RE: RIO GRANDE HIGH SCHOOL- ADDN' & RENOV. (M-11/D4)
(2300 Arenal Rd SW)
ENGINEERS CERTIFICATION FOR CERTIFICATE OF OCCUPANCY
ENGINEERS STAMP DATED 8/15/2000
ENGINEERS CERTIFICATION DATED 10/7/2002

**RE: Grading and Drainage Plan and Master Drainage Plan for Rio Grande High School
(M11/D4) (PWDN-126) Engineer's Stamp Dated 8/15/00.**

Re: Rio Grande High School, 2300 Arenal Street, Grading and Drainage Plan
Engineer's Stamp dated 12-05-07 (M-11/D004)

Rio Grande High School Drainage Report

Figure 3- StormTech Chamber Distribution Layout.

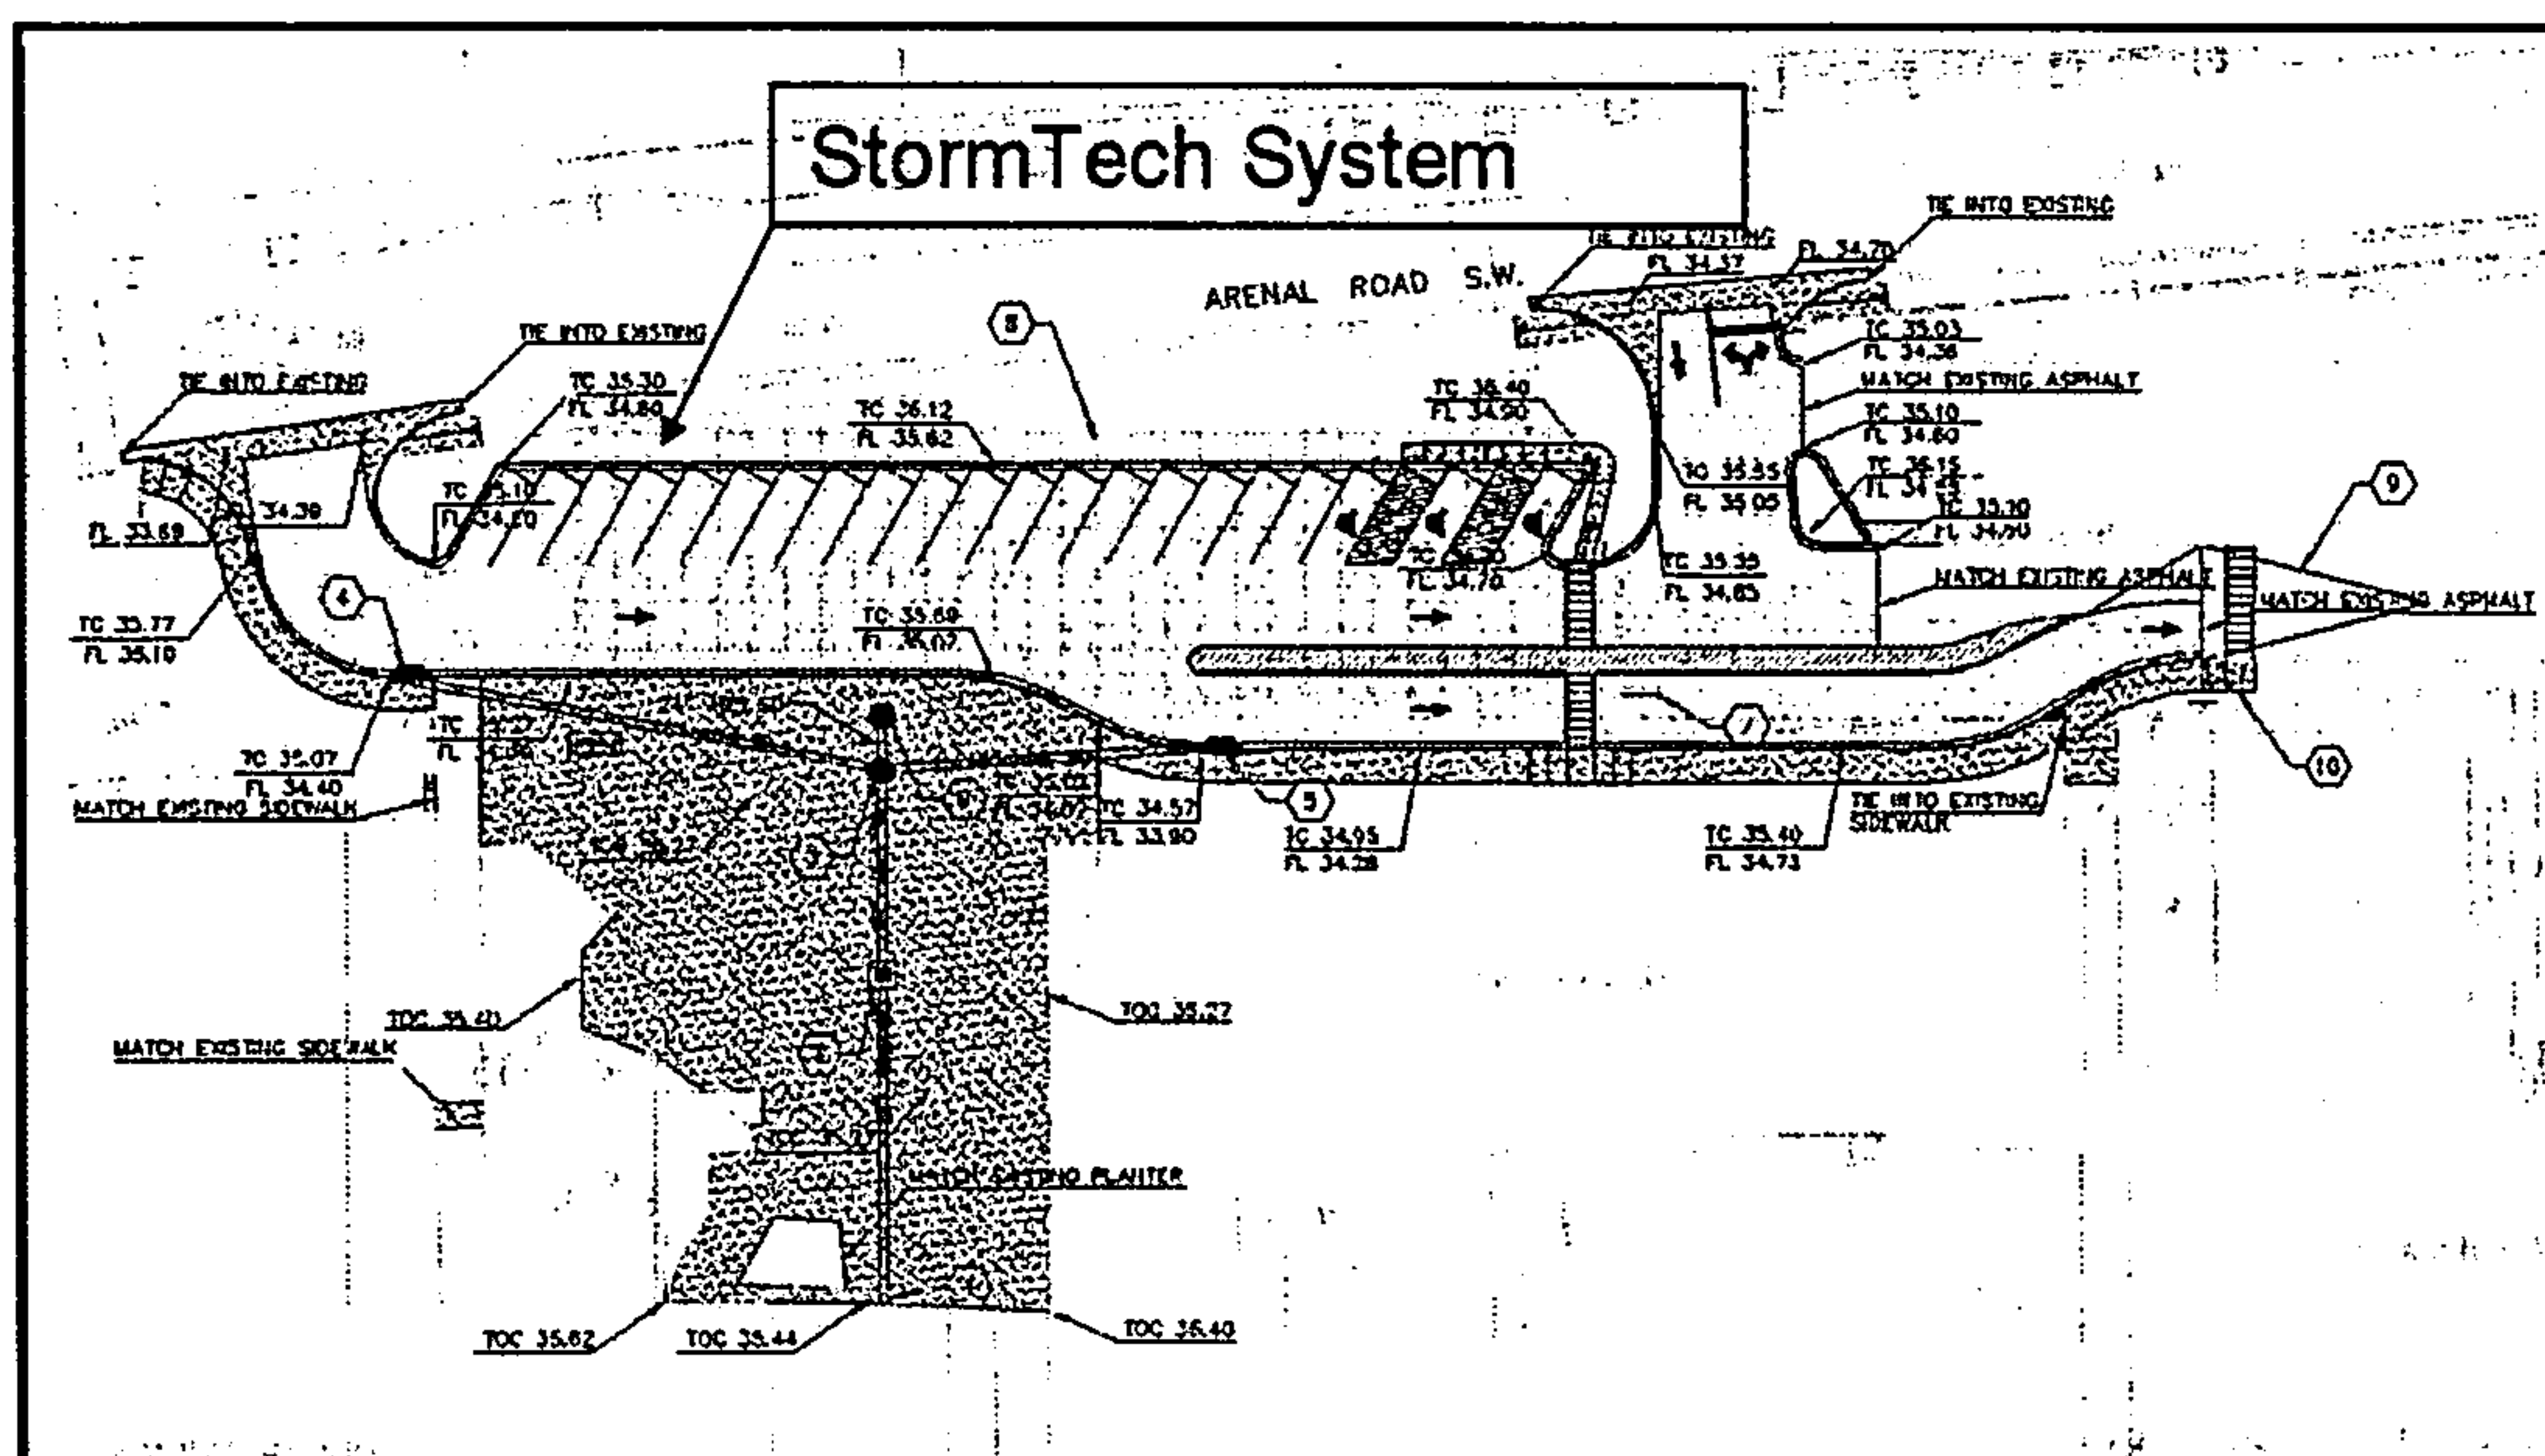
4. Please include Detail Sheets 501 and 502.
5. How and where will the run-off enter the "Storm-Tech Chambers"? Specifications for this system are required.

6. It appears the North West corner of the Storm-Tech Chambers protrudes into the Right-of-Way; this will require an Encroachment Agreement or modify the location of the Storm-Tech Chambers.

Figure 3- StormTech Chamber Distribution Layout.

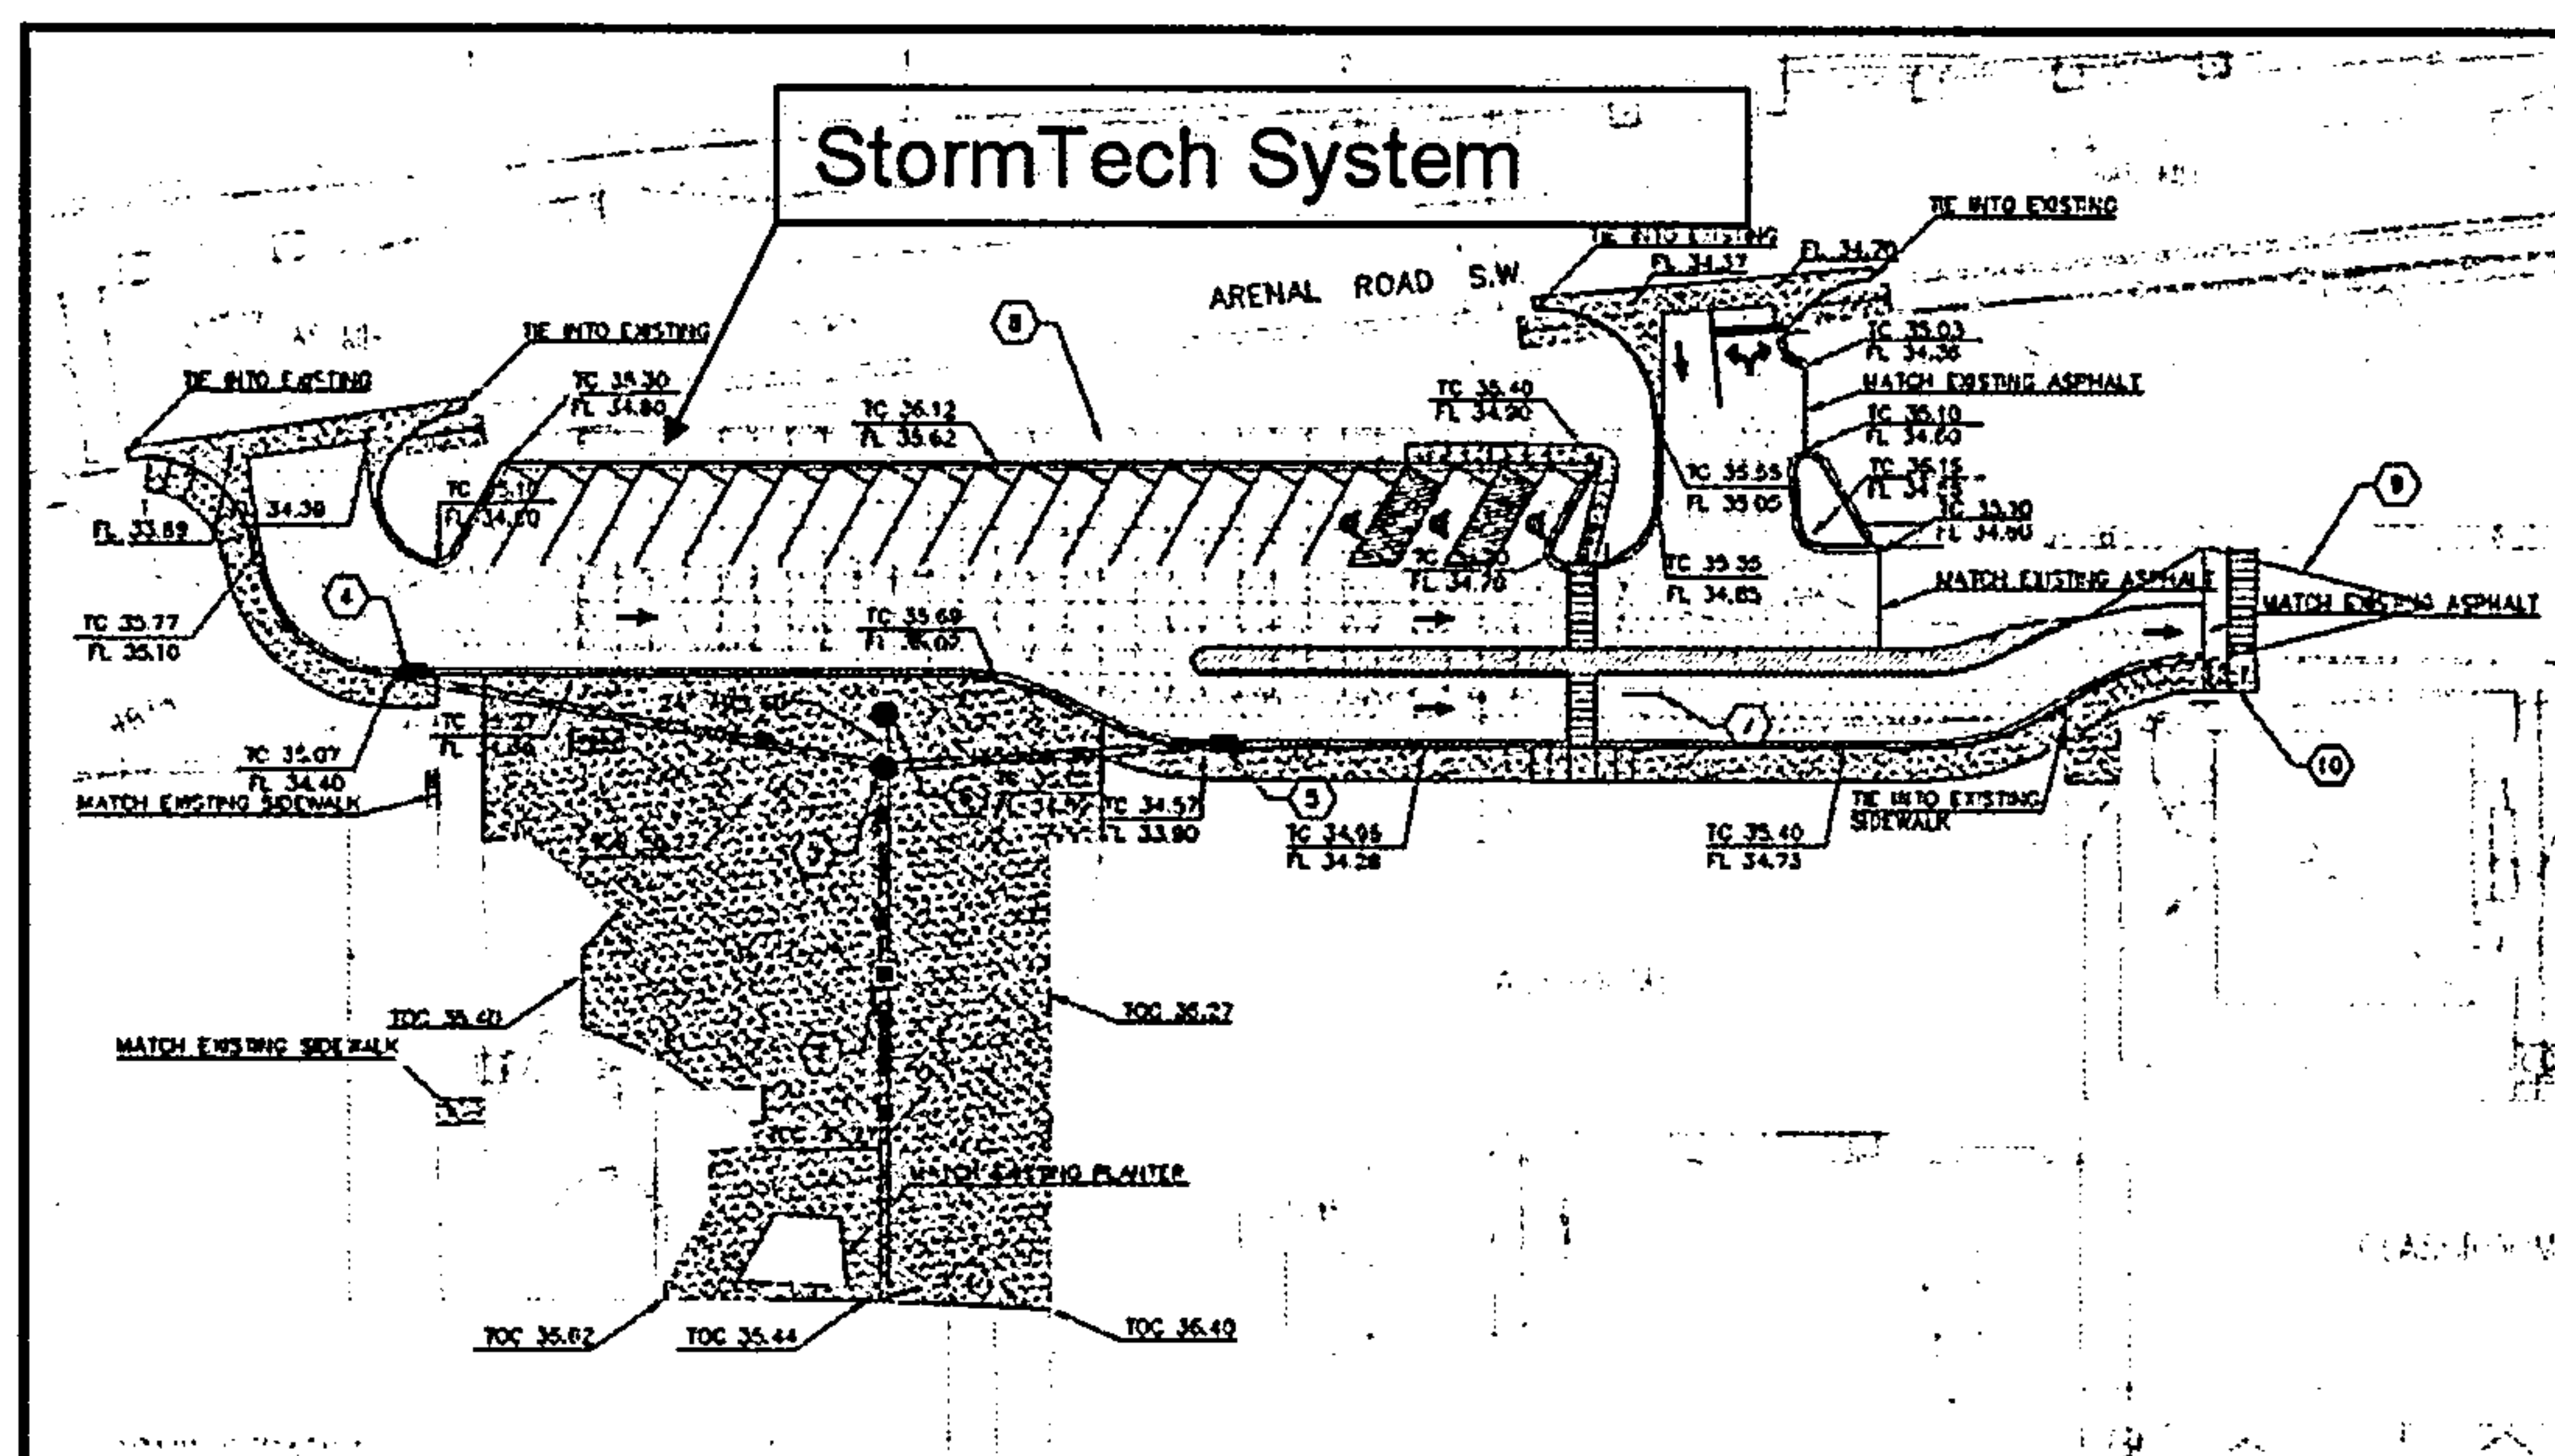
4. Please include Detail Sheets 501 and 502.
5. How and where will the run-off enter the "Storm-Tech Chambers"? Specifications for this system are required.
